KARACHI MUNICIPAL CORPORATION.

Diary sheet in respect of Building Regulation plans received.

PLAN SHOWING PROPOSED ADDITIONS & ALTERATIONS WITH FIRST FLOOR. ON PLOT No. 393 SHEET J.M. 3. FOR THE COSMOPOLITAN CO-OPERATIVE HOUSING SOCIETY LTD. JAMSHED QUARTER. SCALE 8-1.

Reference No. L. C. P. 614/38

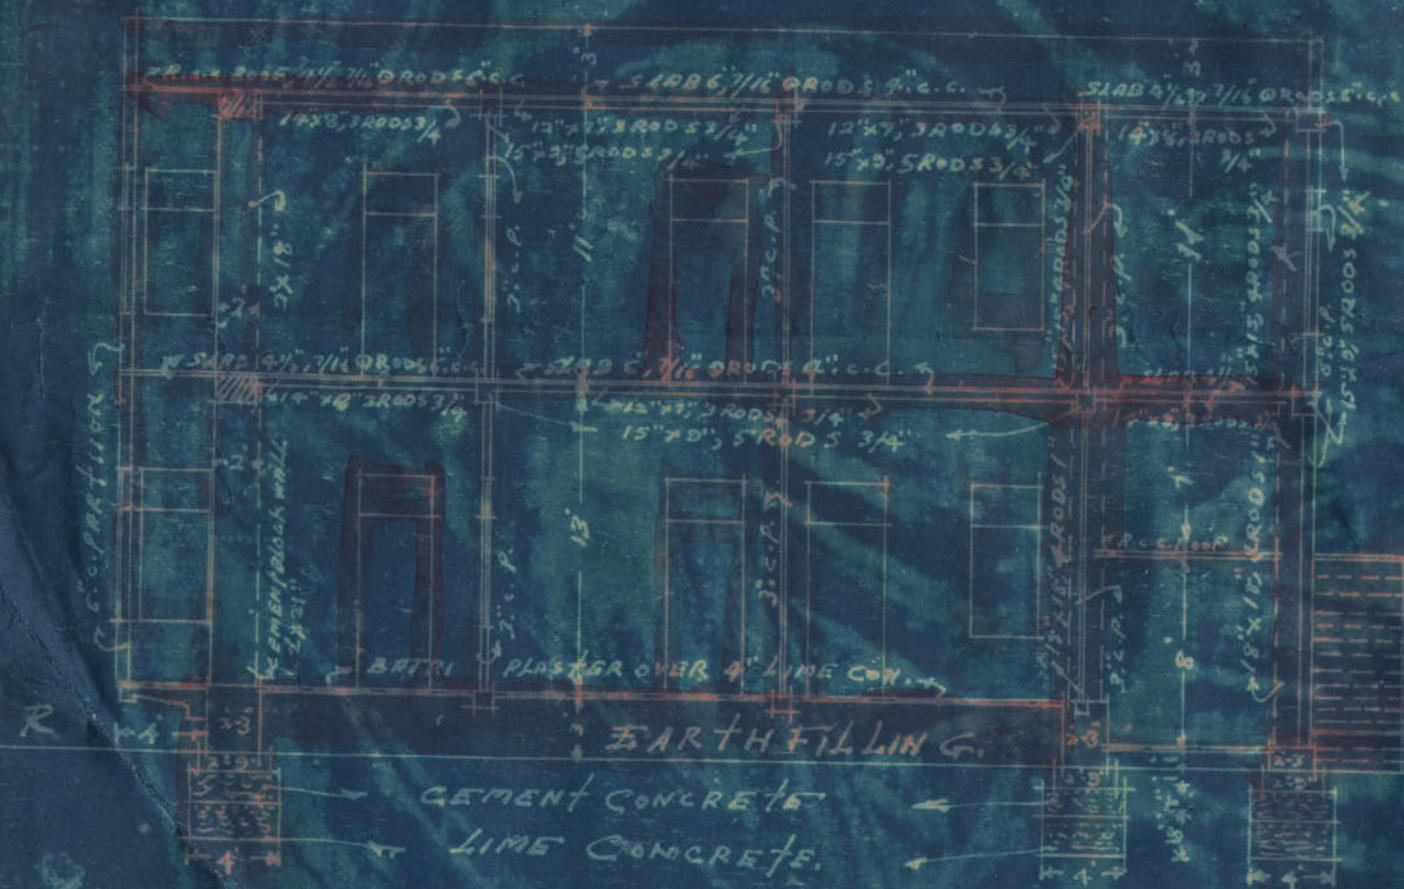
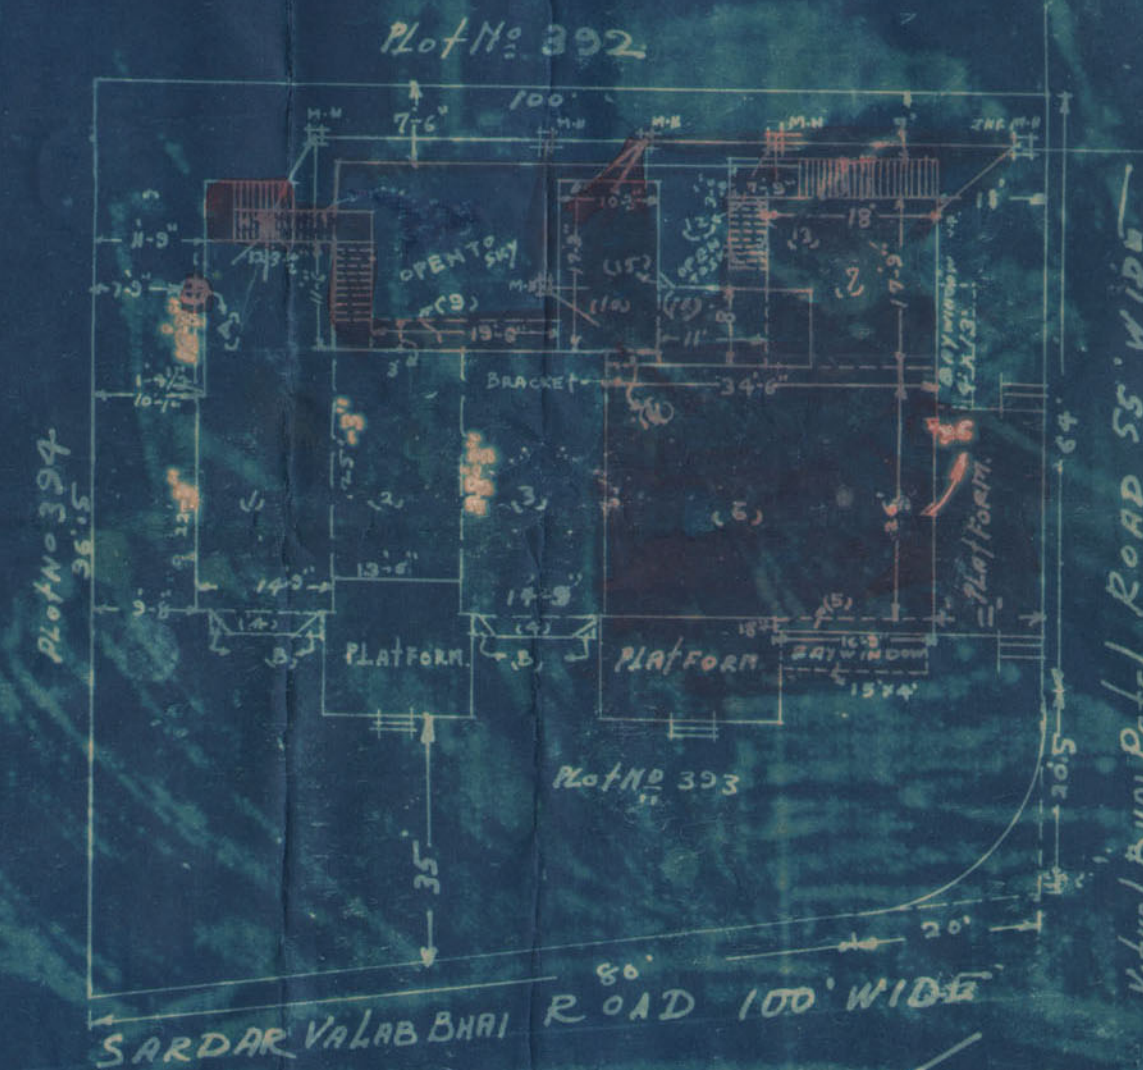
1. Measurements and plot nos. be correctly ~~shown~~ shown.
2. Road name and width be given.

3. Position of O.H. tank should be shown.

W.C. under the staircase can not be allowed.

5. The compulsory open space should be clearly marked on the plan.
6. The spiral staircase should be shown in site plan and its distance from boundary be given.
7. Door to the bay window can not be permitted.
8. Section through the bath and W.C. under landing be given.
9. ~~Raising~~ ^{existing} built up area should be checked with Building Surveyor.
10. W.C. X can not be allowed.

L.S.'s Objections Nos.1 & 2 are complied with.

S.E.'s Objections Nos. 3 is complied with.

H.O.'s Objection No.4. W.C. under the staircase has been removed.

L.M.'s Objections Nos.5,6,8 & 9 are complied with.

✓ Re: No.7, door has been removed and window put instead.

✓ Re: No.10. W.C. marked X has been removed.
